September 30, 2022

Version 3

## Safety Recall: 2019-20 TLX SH-AWD Fuel Pump Motor

Supersedes 21-017, dated August 6, 2021, to revise the information highlighted in **yellow**.

27. Install the fuel pump into the fuel filter.

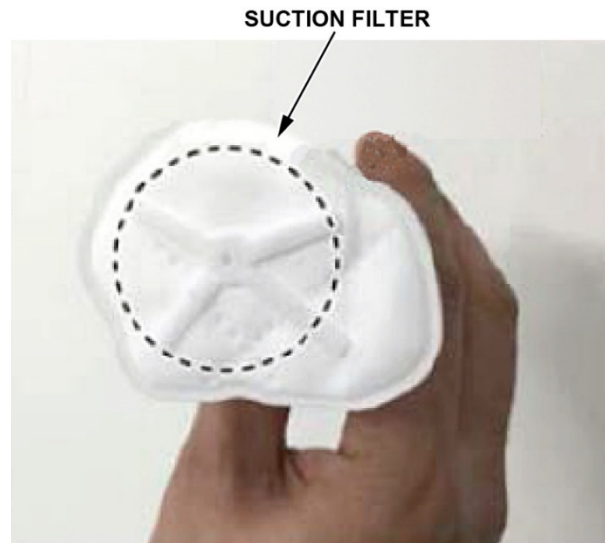
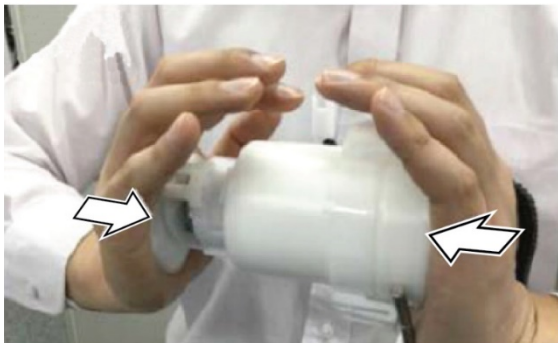
Under REPAIR PROCEDURE, step 27 was revised and an image was added.

- Be careful inserting the suction filter so it doesn't break. Use the palm of your hand to push in the entire surface of the suction filter into the module.
- After installing the fuel pump to the strainer, move the lock of the suction filter back and forth to make sure there is no rattling
- If installation with a single push is not accompanied by a click, remove all parts, reset the O-ring, then assemble it again
- The O-ring cannot be reused once assembled. Replace it with a new one, then reassemble
- Be careful that the flange does not hit any other items because this may lead to a fuel leak

GOOD

NO GOOD
